Analysis Branch
Division of Systems Safety
Office of Nuclear Reactor Regulation

SAFETY EVALUATION REPORT
ON
ECCS EVALUATION MODEL
FOR
WESTINGHOUSE TWO-LOOP PLANTS

November 1977

SAFETY EVALUATION SUPPORTING CONTINUED SAFE OPERATION
OF WESTINGHOUSE DESIGNED TWO LOOP PLANTS.....

Pumped Upper Plenum
Injection

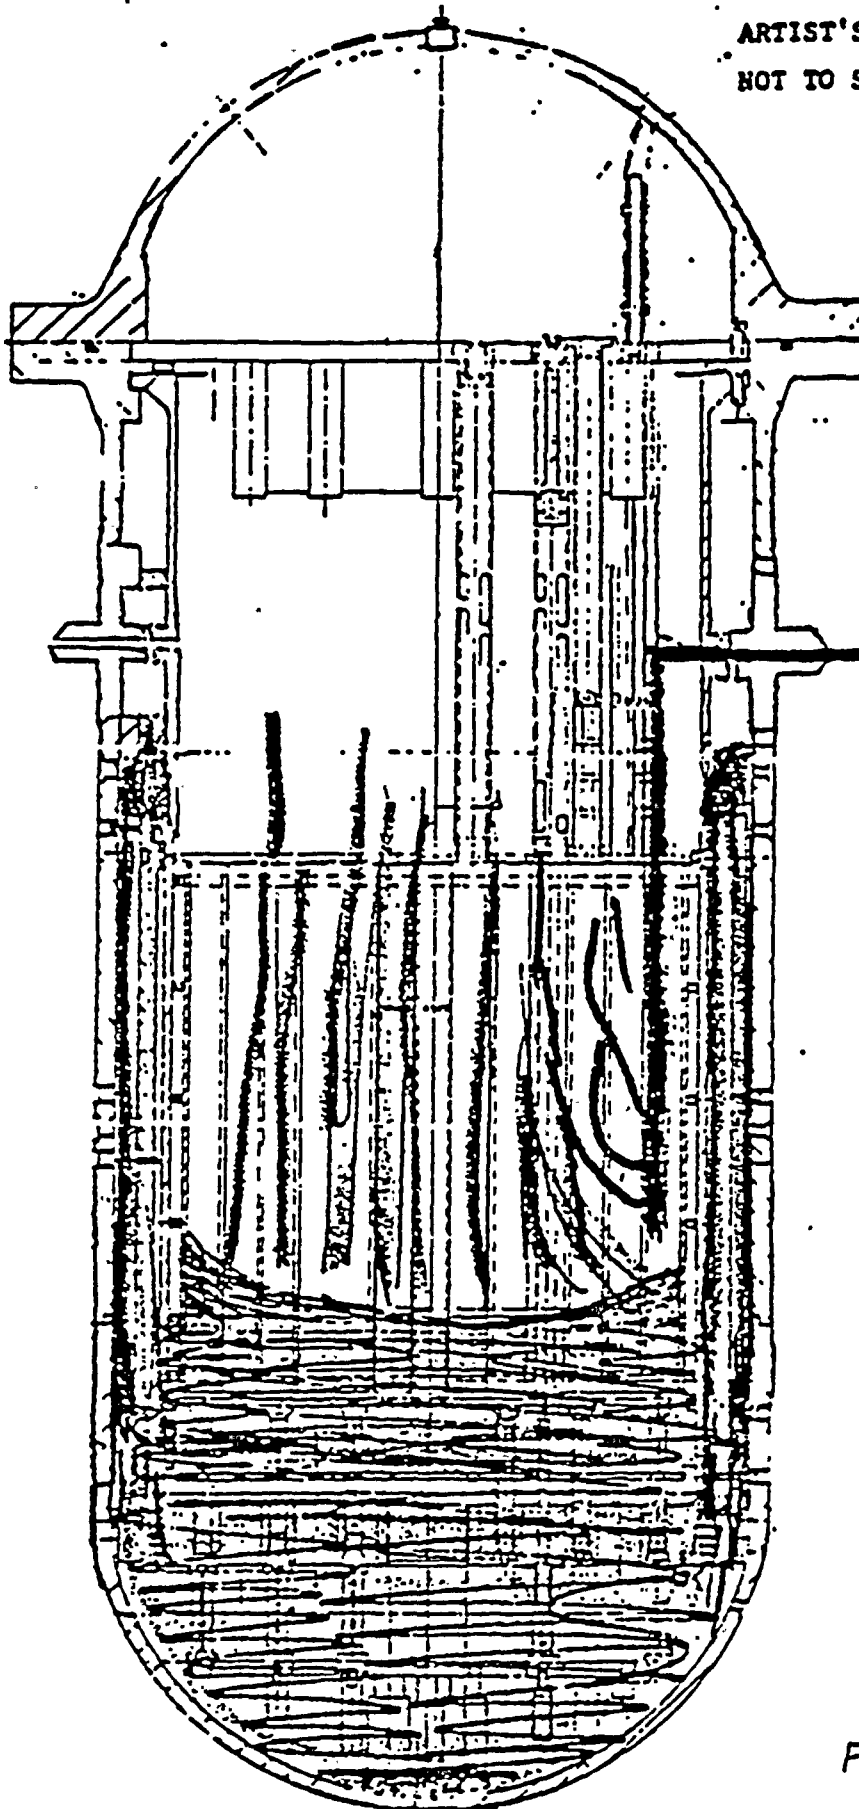
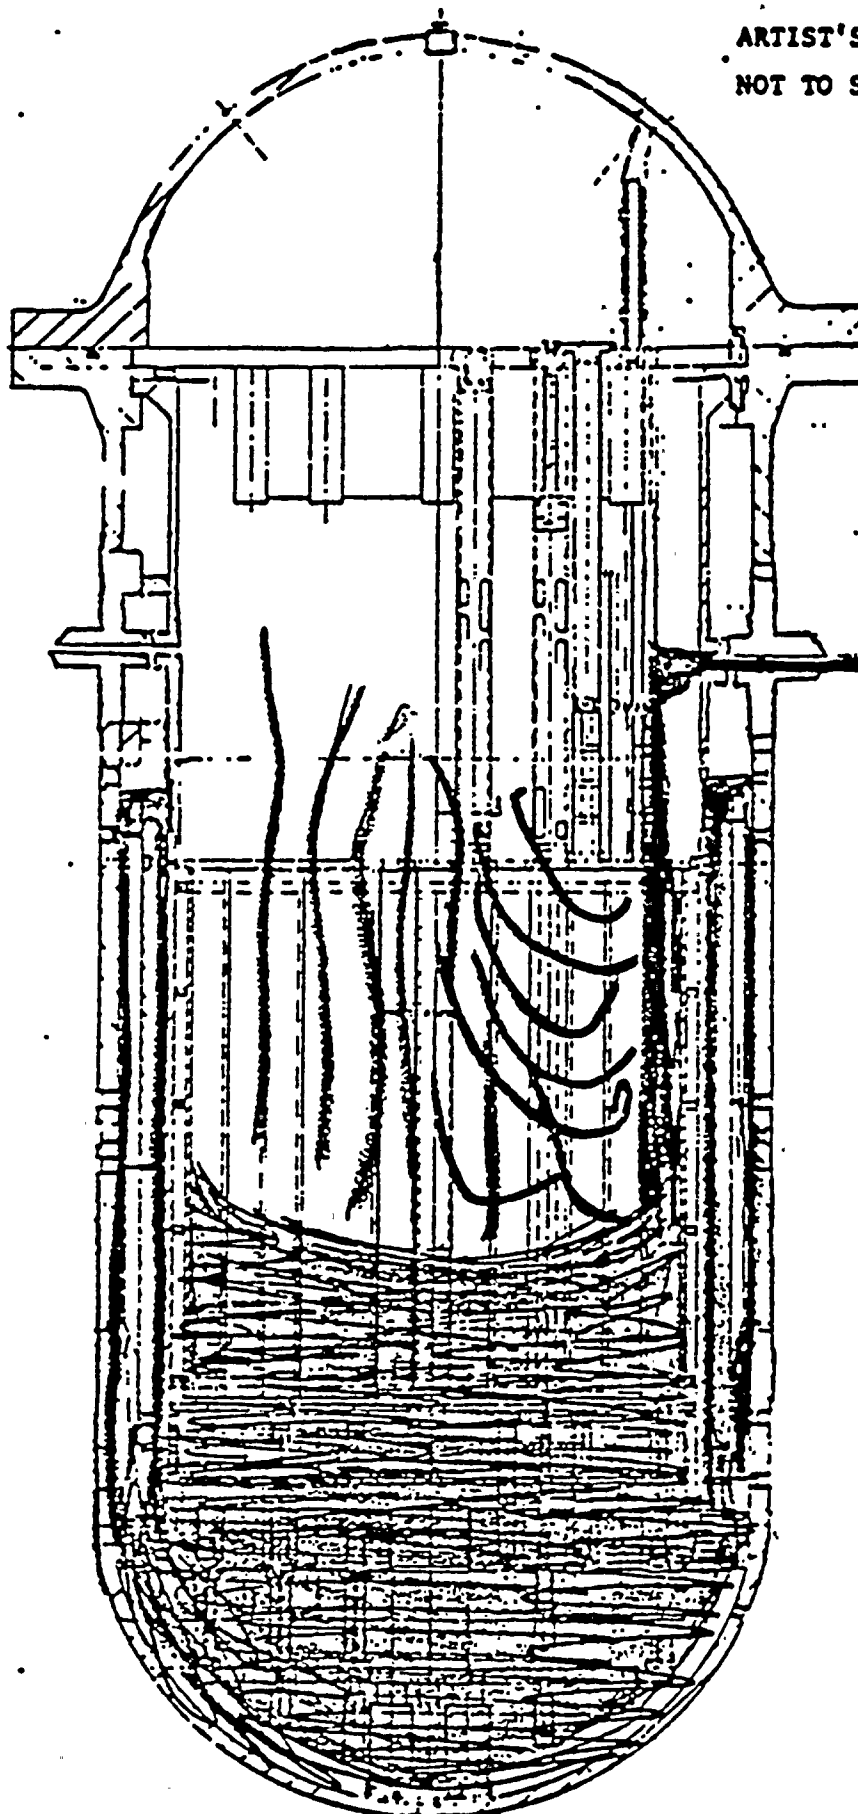
The key element in viewing the effects of upper plenum injection is the upper plenum injection flow distribution. The flow distribution is the controlling factor relative to steam generation, steam condensation and upper plenum injection water entrainment. The two-loop plant designer (Westinghouse) and the plant licensees description of the upper plenum injection flow distribution during blowdown, refill and reflood is shown in Figures 12 through 18.

Our review of the available information on upper plenum flow distributions indicates that the view of upper plenum injection as a highly localized flow (as presented by Westinghouse and the two-loop plant licensees) is not correct and is non-conservative. We conclude that the data supports the concept of a widely dispersed droplet flow in the upper plenum. For this condition, an integral model which treats the interactions among the controlling phenomena (i.e., heat transfer and quench; steam generation; entrainment and flooding; reflood rate) is required to establish the important assumptions; to identify the proper sensitivities to parameter changes; and to assess the overall effect on peak clad temperature. For these reasons we have constructed a simple, quasi-static model to study the bounding effects of upper plenum injection, and the sensitivity to various assumptions. In this model the reflood rate is calculated by adjusting the current evaluation model calculation of reflood rate to account for the additional steam generation associated with UPI.

Figure 25

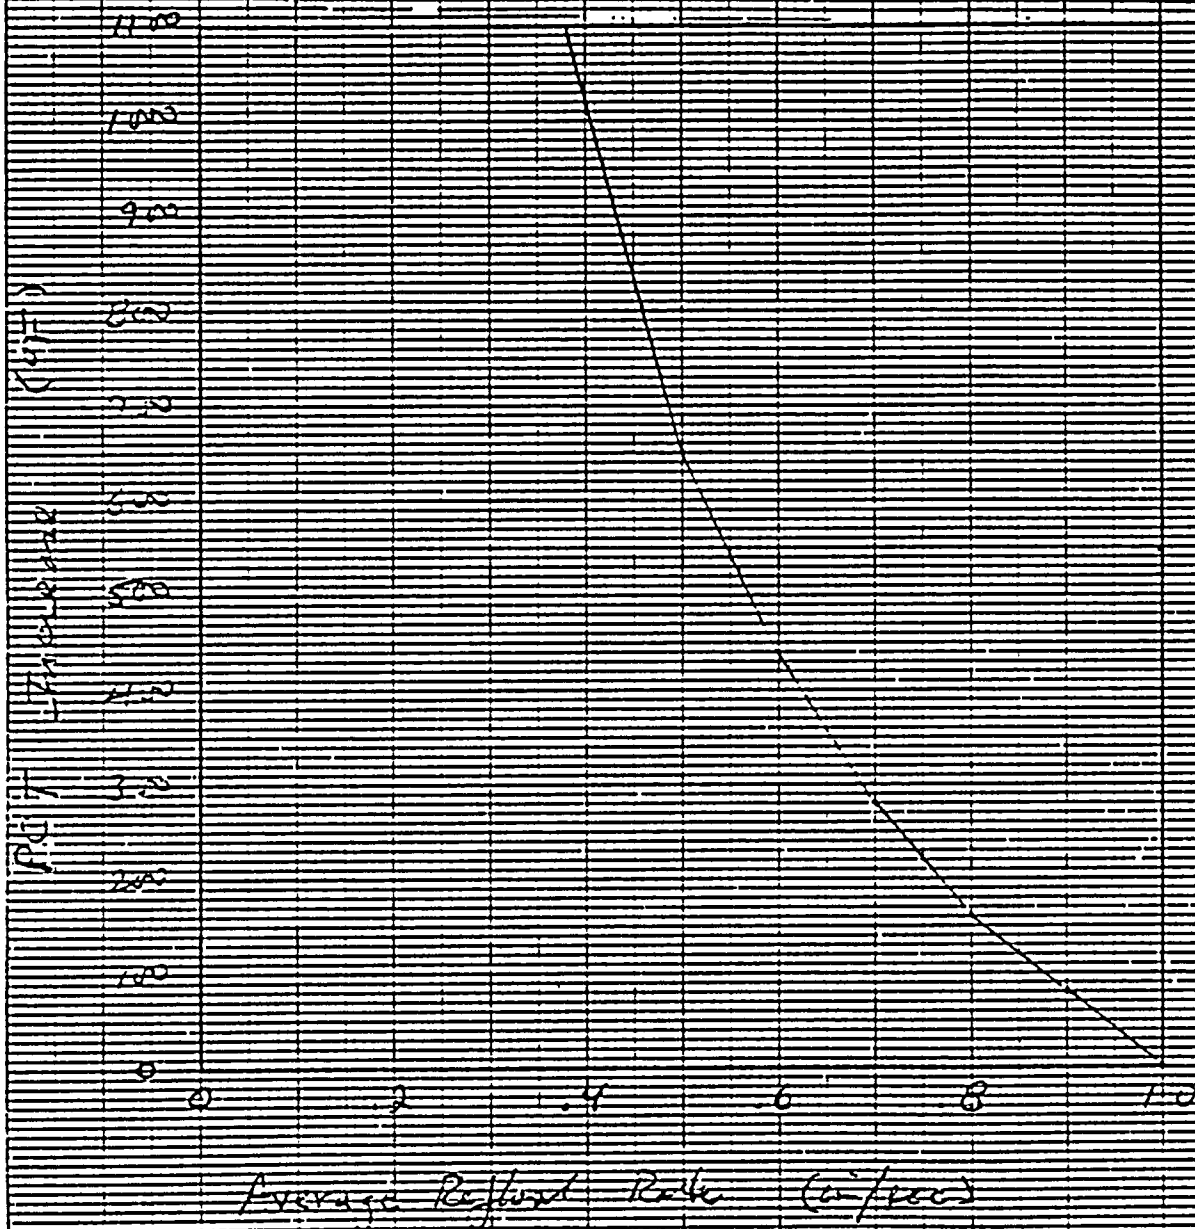
The staff model assesses a penalty on peak clad temperature to account for the generation of steam due to upper plenum injection. Figure 25 presents the peak clad temperature penalty as a function of initial power level. At approximately 50% power, the heat being removed from the core can no longer be absorbed completely by the initial subcooling of the upper plenum injection water and the result of steam generation in the core can be seen in the figure. At 92% power, entrainment of upper plenum injection water begins and the penalty on peak clad temperature increases rapidly. This rapid increase is a reflection of the rapid increase in entrainment which occurs after the onset of entrainment.
